**RE: Request to Eliminate Surface Water Sampling Point SW-1  
Piedmont Landfill and Recycling Center  
Permit No. 34-06  
JEI Project No. 392.0900.12, Task No. 88**

**PIEDMONT LANDFILL  
 KERNERSVILLE, NORTH CAROLINA**

**SURFACE WATER MONITORING POINTS**

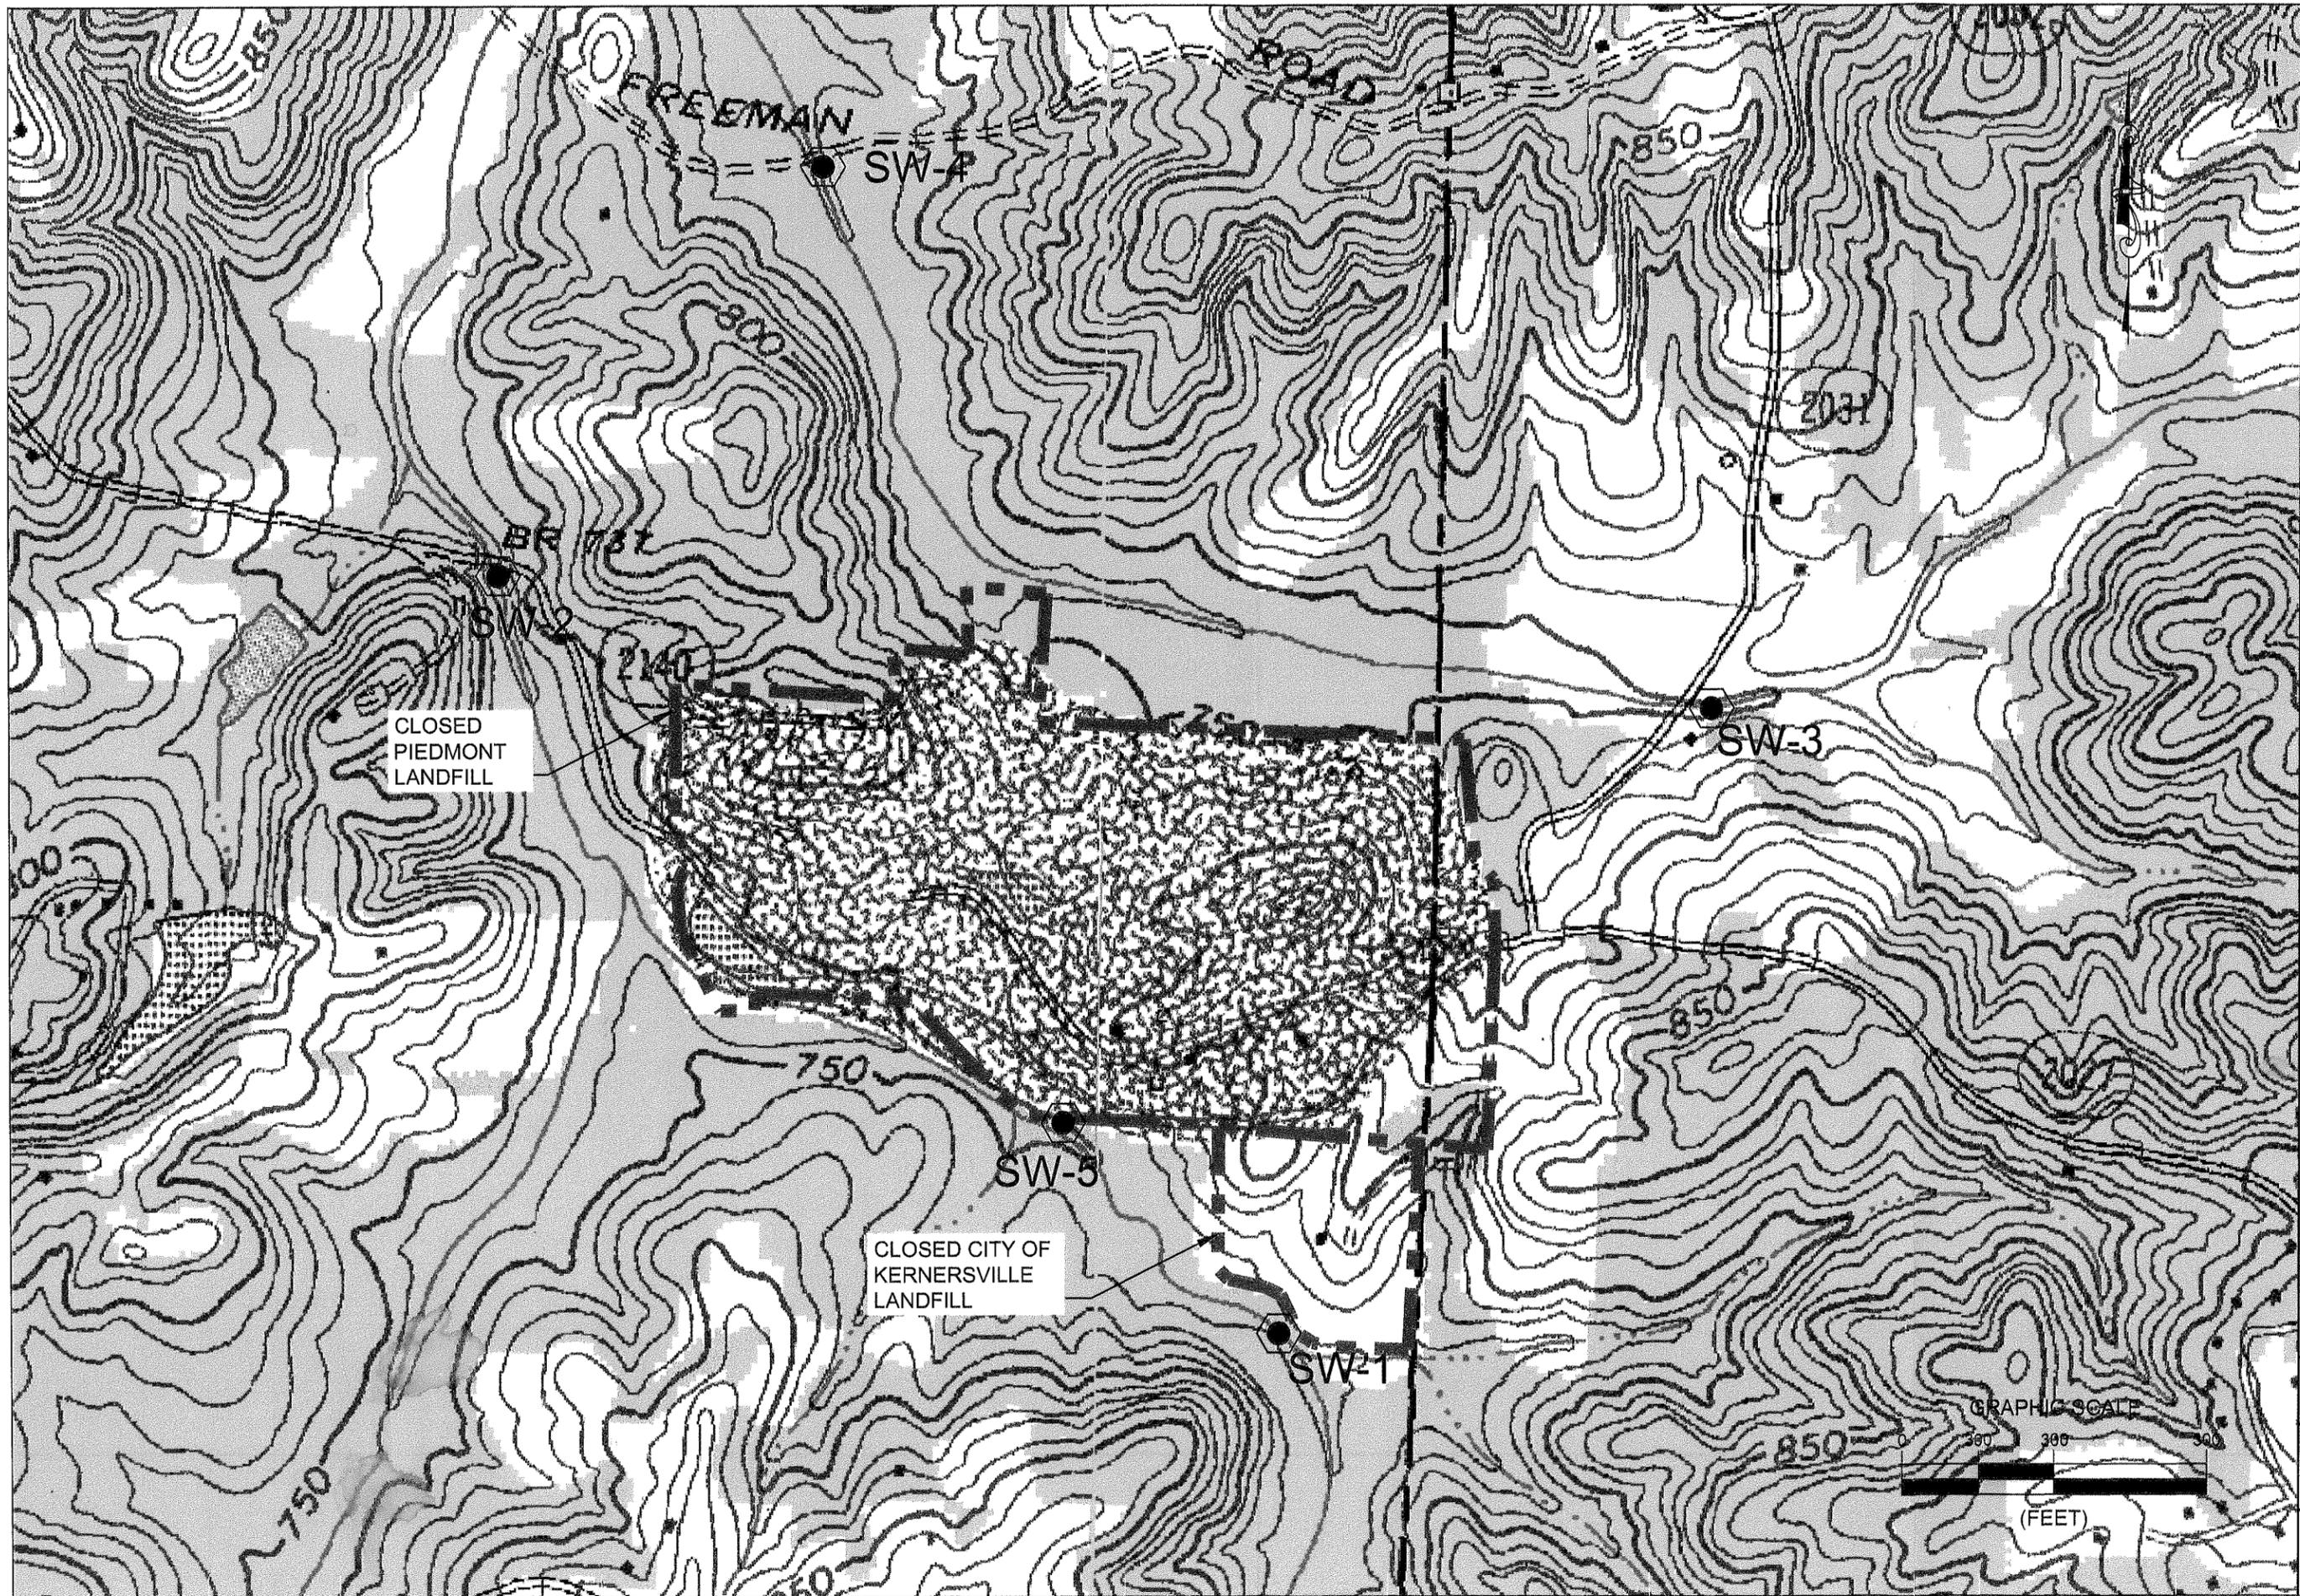
I am in the process of reviewing your request for the Piedmont Landfill in regards to the removal of SW-1. Based upon my file review, samples collected from SW-1 have indicated detections of several VOCs over the years including 1,1-dichloroethane, cis,-1,2-dichloroethene, vinyl chloride, and acetone. To date, all of the concentrations have been “J” flagged and are detected below the NC Groundwater and Surface Water Standards. Based upon the maps located within the files, groundwater monitoring wells MW-01 and MW-06 are the closest wells to the SW-1 location, and both wells do not indicate detections of VOCs at this time. The closest groundwater monitoring wells to the SW-5 location are MW-12 and MW-12D. However, there is not a groundwater monitoring well located between MW-1 and MW-12/12D. As a result of the file review, I have three questions: (1) what is/was the technical reason for the location of SW-1, (2) how can it be determined if the VOC detections are from the Piedmont LF and/or from Kernersville LF, and (3) when was SW-1 placed within the Water Quality Monitoring Plan (how long has SW-1 been sampled)?

- 1) JEI was not involved in the original establishment of the surface water monitoring points; however, I believe the reason for SW-1 being located where it is was to document whether there was stream impact from the old Kernersville Landfill before the stream could be impacted by the Piedmont Landfill.

- 2) SW-1 is more than 750 feet from the Piedmont Landfill edge of waste in a cross-gradient direction relative to documented groundwater flow paths; whereas, SW-1 is less than 50 feet from the Kernersville Landfill edge of waste. Furthermore, for impacted groundwater from the Piedmont Landfill to reach SW-1, it would have to flow under the Kernersville Landfill. It seems pretty clear that the estimated VOC detections at SW-1 are much more likely to be coming from the Kernersville Landfill than the Piedmont Landfill.

- 3) I believe the surface water points were first established in the Water Quality Monitoring Plan prepared by Rust Environment & Infrastructure in 1993. SW-1 has been sampled since at least 1994. JEI does not have records before that.
